DESIGN REVIEW BOARD
1200 STEWART STREET
 EARLY DESIGN GUIDANCE

NOVEMBER 25, 2008
 DPD PROJECT 3007548

EARLY DESIGN GUIDANCE RECOMMENDATION
FROM PAGE 9

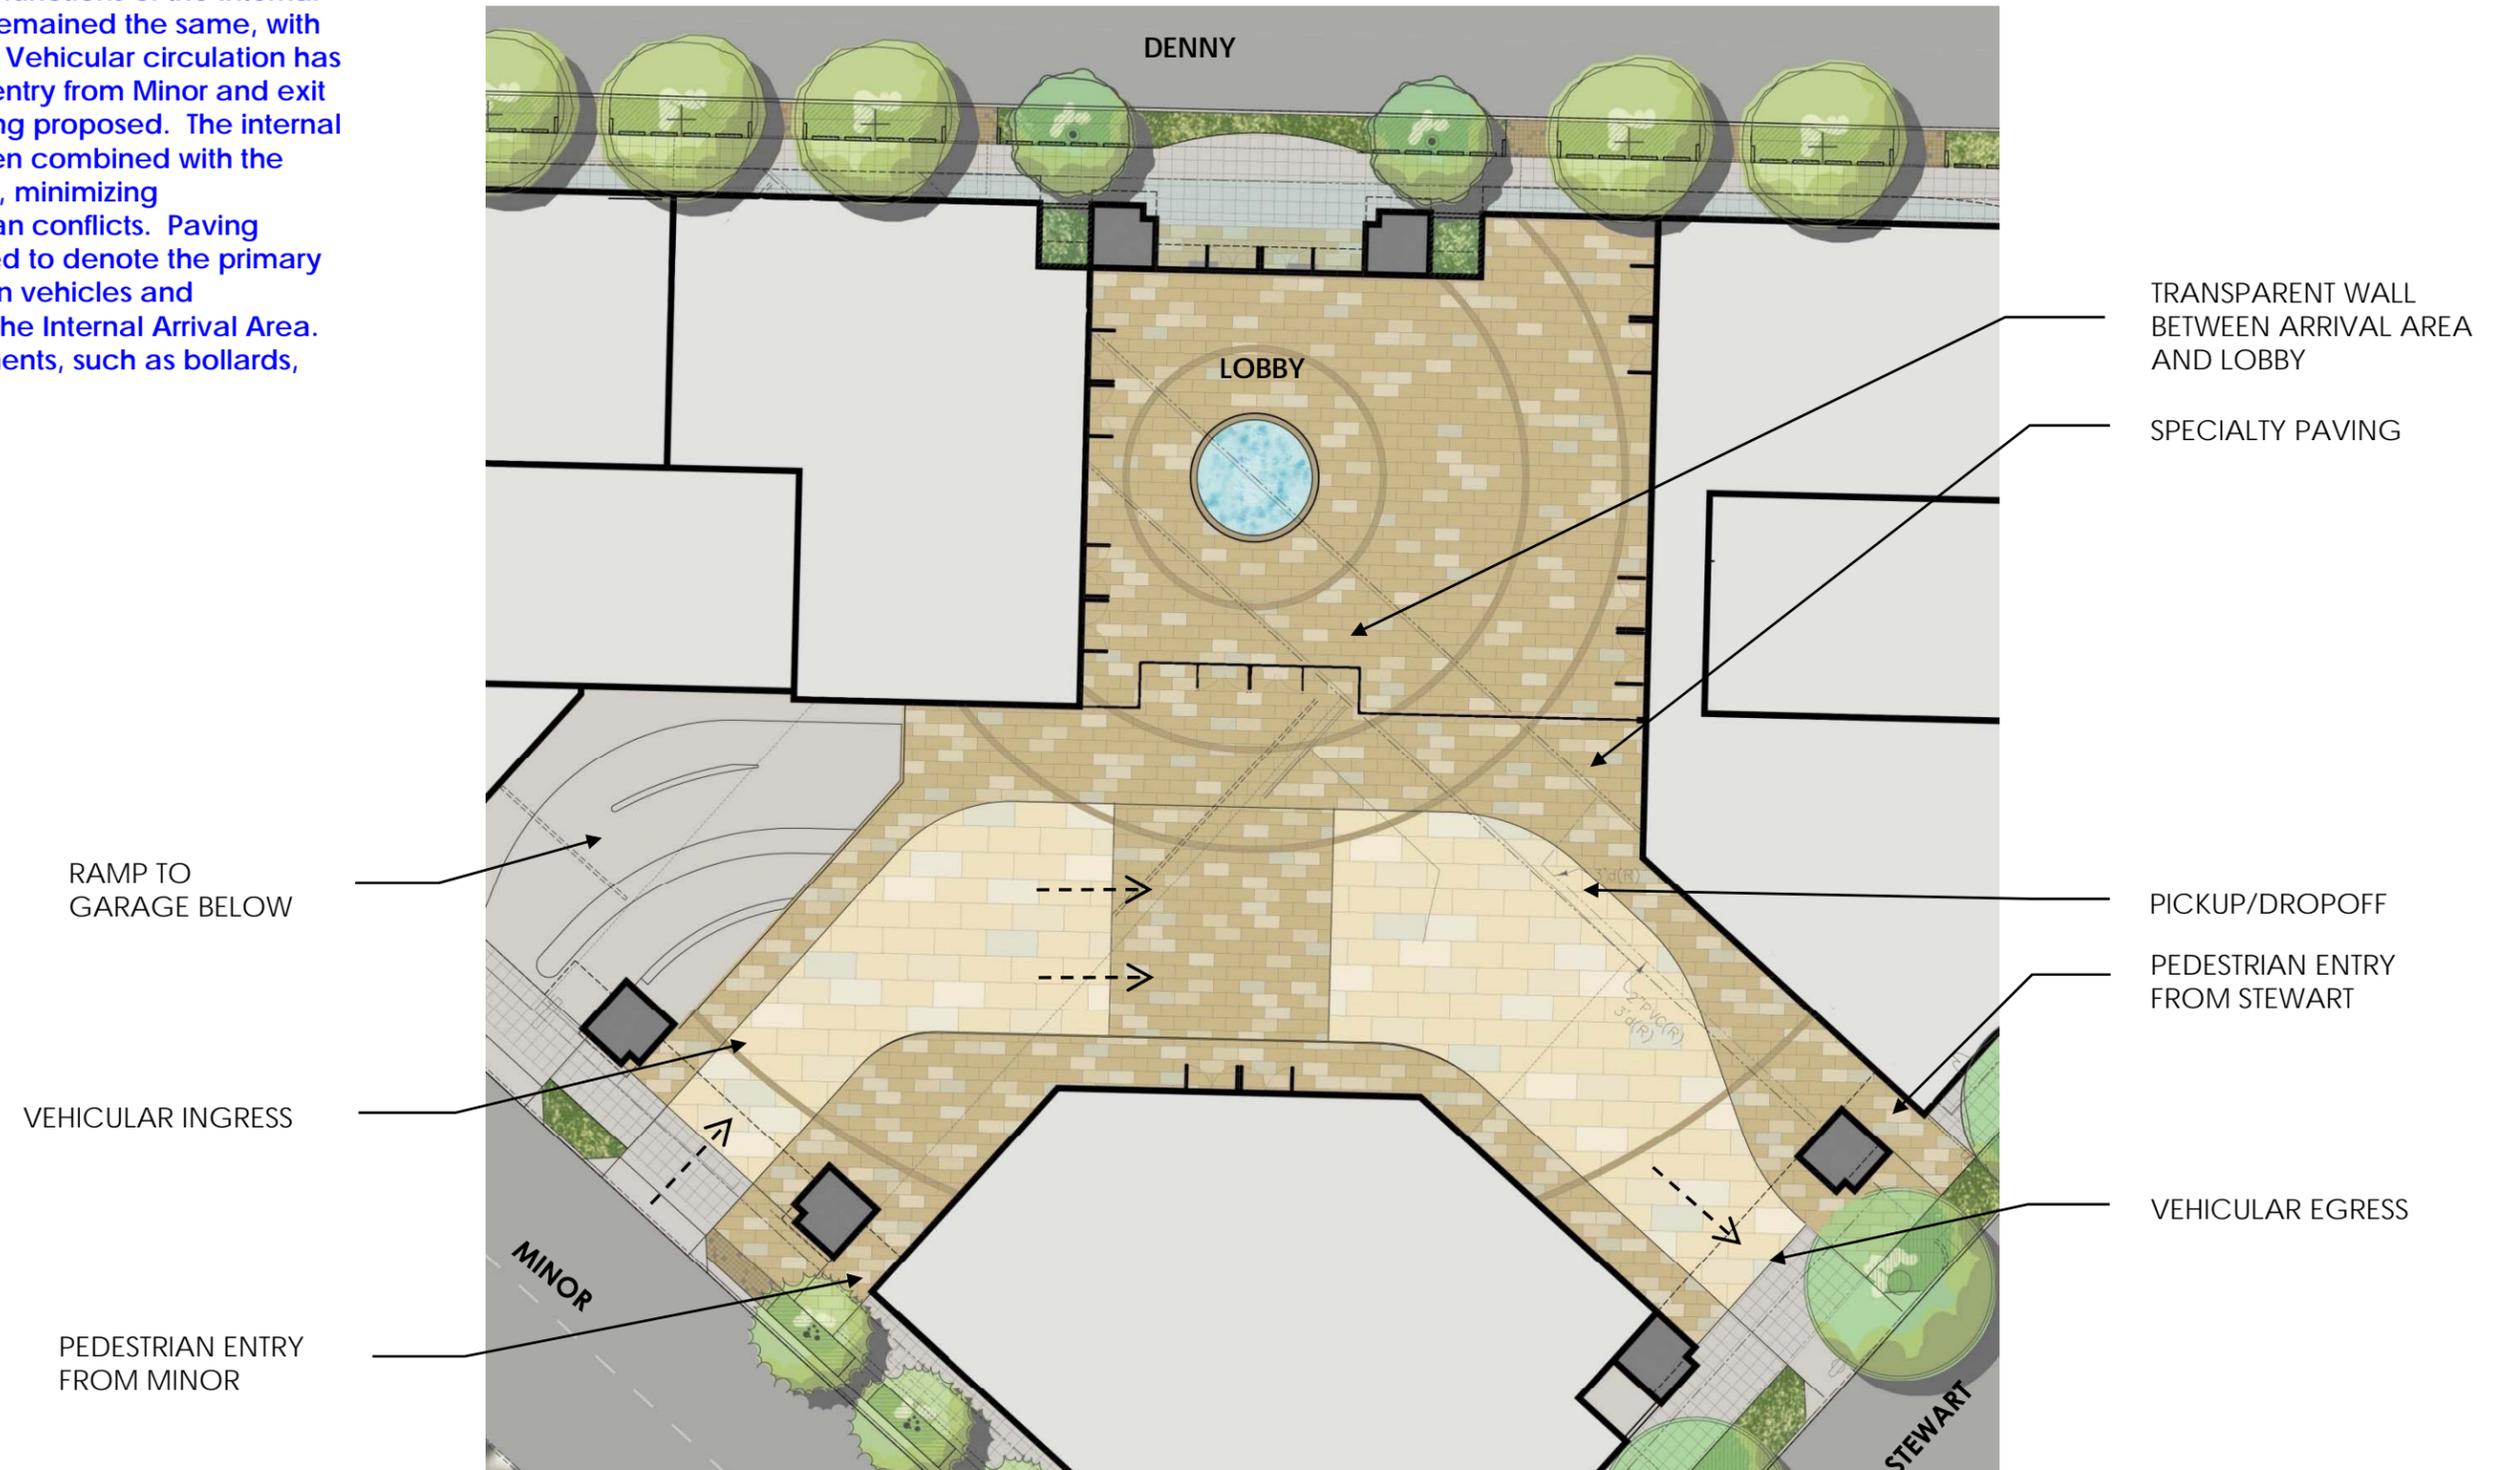
COMMENT: Submit specific study (perspectives, etc.) of the Porte-cochere space; relationship of vehicle to pedestrians, light quality, transparencies, etc.

RESPONSE: Basic functions of the Internal Arrival Area have remained the same, with some refinements. Vehicular circulation has reversed, with the entry from Minor and exit to Stewart now being proposed. The internal valet ramp has been combined with the main garage ramp, minimizing vehicular/pedestrian conflicts. Paving color/pattern is used to denote the primary separation between vehicles and pedestrians within the Internal Arrival Area. Other vertical elements, such as bollards, may be used.
